SUPPLEMENTARY TRAFFIC STUDY

BERRY HILLS PHASE 8

PREPARED FOR:
ARMCO CAPITAL INC.

SEPTEMBER 3, 2019

Figure 1: Travel Patterns and Trip Distribution

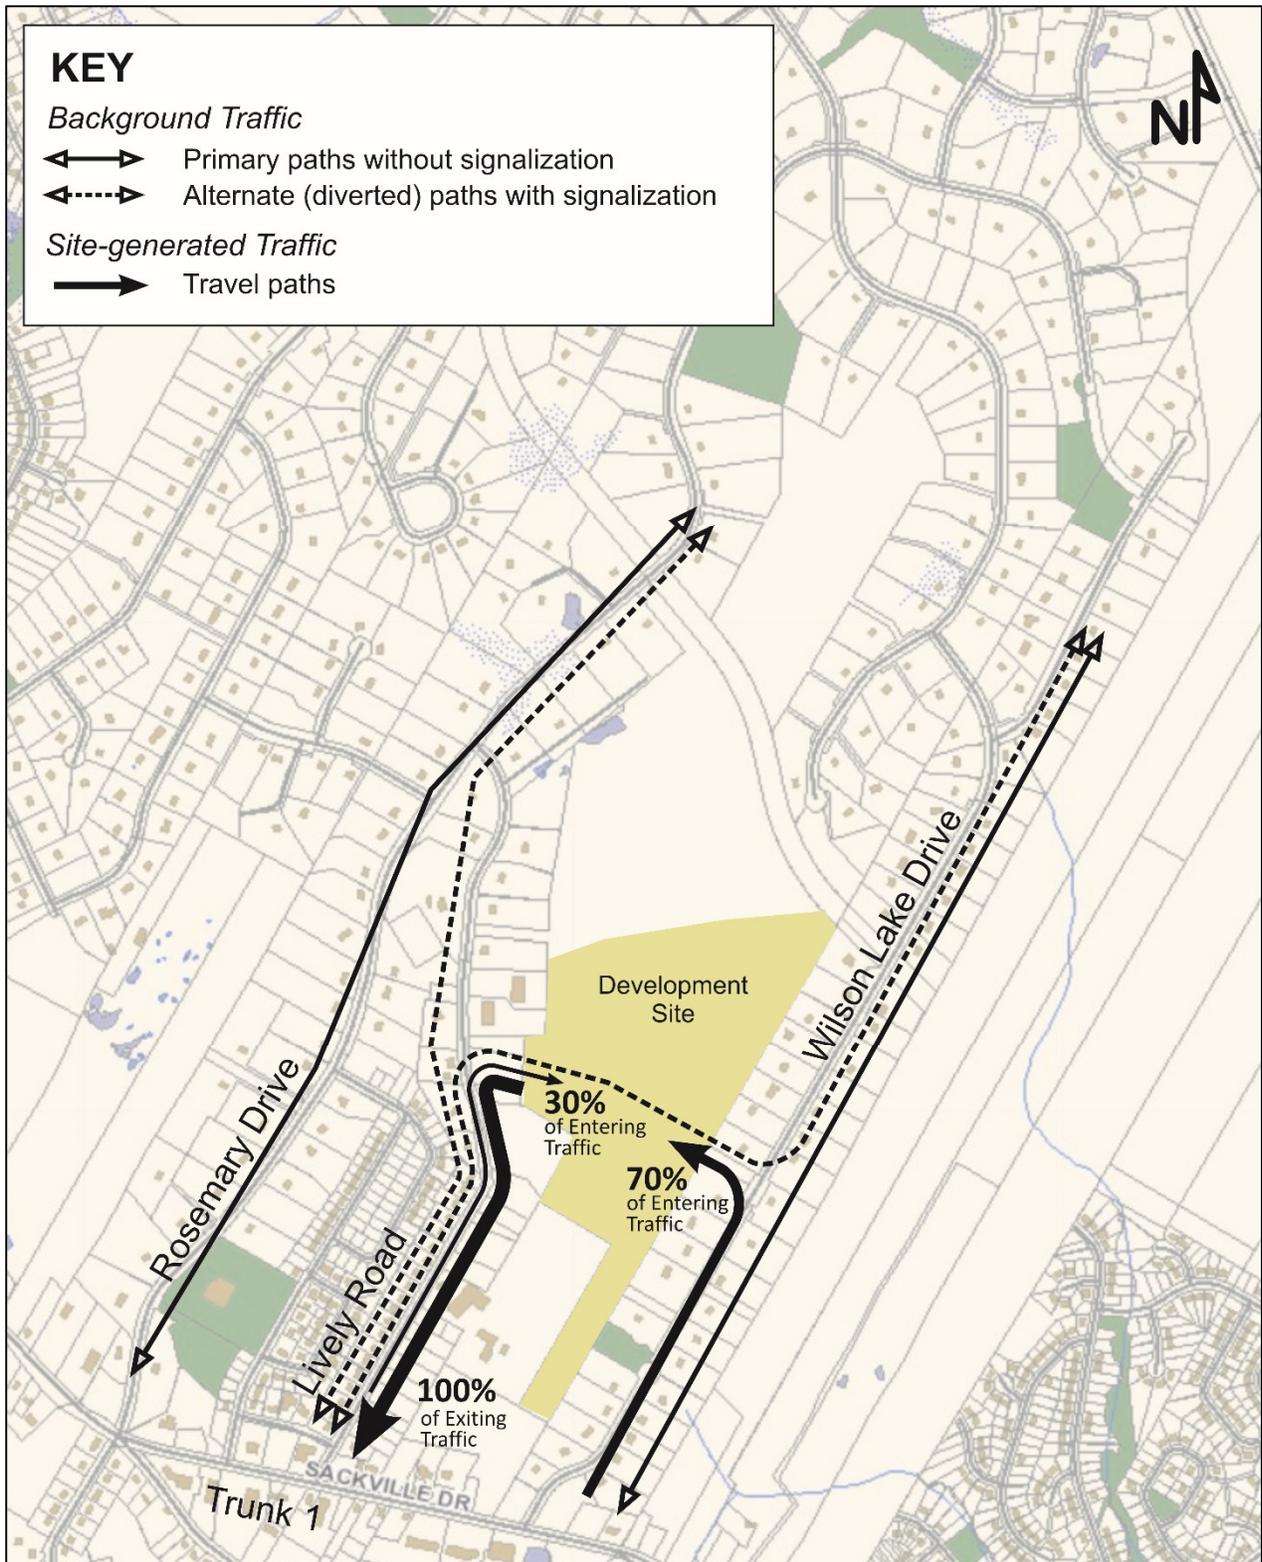
- 1) **“Identification of the transportation system changes needed to mitigate the impact of the proposed development on the transportation network have not been adequately addressed. The report findings show that the proposed development will significantly affect traffic operations. Although there are projected operational issues with background traffic growth, the additional site-generated traffic must not worsen the situation as required in section 6.3 of HRM’s Guidelines for the Preparation of Transportation Impact Studies (8th Revision).”**

- This report introduces a plan to provide better access management control on Trunk 1 through the signalization of the Trunk 1/Lively Road intersection. The plan diverts traffic away from unsignalized intersections where stopped delay is significant to a signalized intersection that provides adequate level of service. Some of this diversion will occur naturally due to the desire of drivers to migrate towards the intersection with better service and safety and some will be forced through the redesign of the proposed subdivisions connections.

Access Plan Our access management plan recognizes that a poor level of service is created with traffic attempting to make a left turn from a stop-controlled intersection leg on unsignalized intersections along Trunk 1. Collision history shows some collisions that occurred here are likely related to the difficulty vehicles experience turning onto Trunk 1 from these intersections. For these reasons, we have redesigned the connections from the development site to the roadway network to direct all trips exiting the site to Lively Road. We then propose to signalize the Lively Road/Trunk 1 intersection to safely manage this increased traffic. All trips entering the site will remain as modeled in the Harbourside study.

To achieve this, we will create the connection between Wilson Lake Drive and the development site as a one-way street into the site. All trips exiting the site will be required to use Lively Road. This plan will not affect emergency access into the site and will not force changes to existing traffic patterns (although we expect these patterns to change naturally once signalization is implemented).

This plan is shown in Figure 1.

Figure 3: Proposed Layout of One-way Connection to Wilson Lake Drive

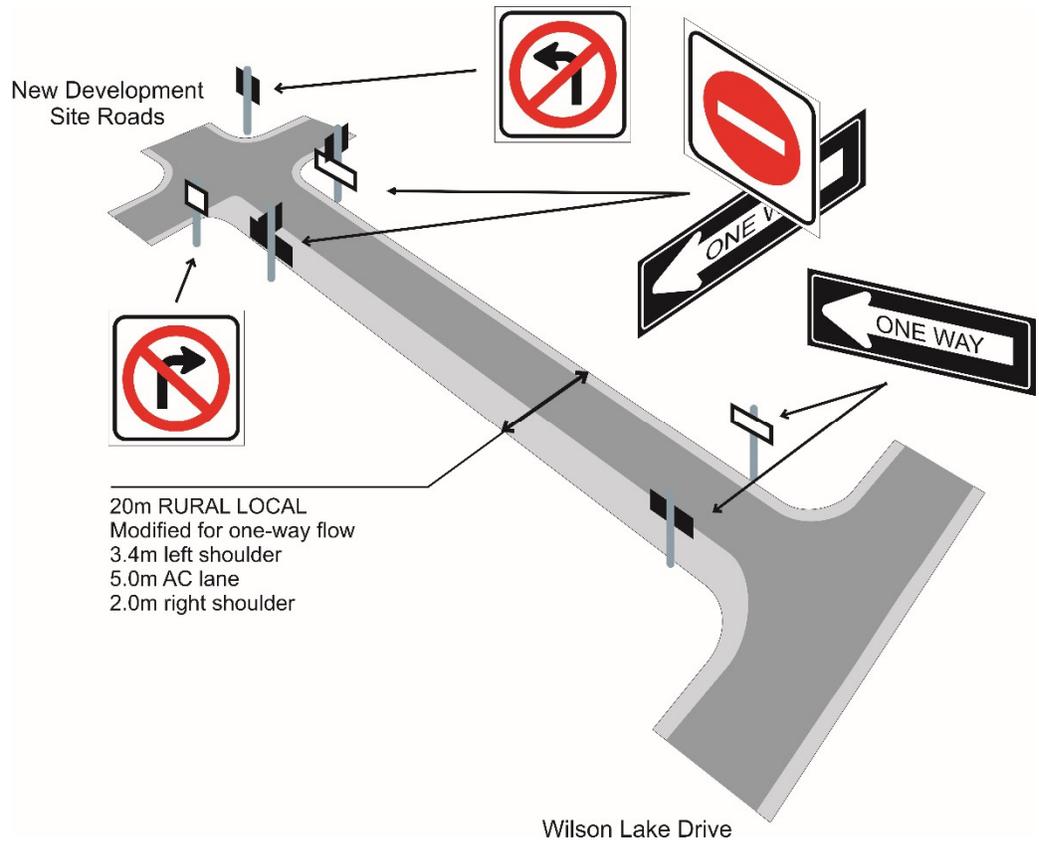
- 4) **“HRM will be implementing traffic calming measures (speed humps) on Wilson Lake Drive and Lively Road in 2019. As mentioned previously, the recommendation to install a compact roundabout on Wilson Lake Drive at the new intersection to the development would be strongly supported by HRM Traffic. This should also be taken into consideration on the Lively Road side of the development.”**

To help guide traffic exiting the proposed develop and areas around it to Lively Road where better level of service is provided, it is recommended that the connection between the development site and Wilson Lake Drive be one-way westbound (inbound to the development). Figure 3 shows conceptually how that roadway would be designed and signed to enforce one-way flow.
